## **SERVICE BULLETIN RMC-013**

### **Product: Receiver Multicoupler**

**Subject: Firmware 1.71 Release**

**Date: 15<sup>th</sup> January 2020**

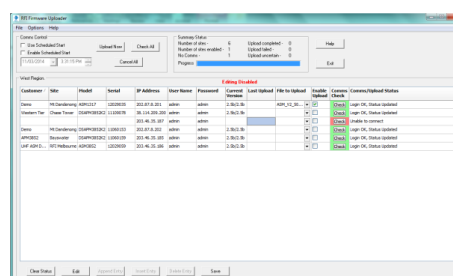
The use of an external 10dB attenuator to set the Expansion Port gain when the RMC is using Config Switch position 7 (for those RMC models offering this operation mode) was changed in version 1.70. The 10dB of attenuation is now applied to the Expansion Port by the RMC's internal attenuator. Systems operating using Config Switch position 7 should have the external 10dB attenuator on the Expansion Port removed if the RMC has been upgraded to version 1.70 (or above). Version 1.71 is fully compatible with all earlier production units.
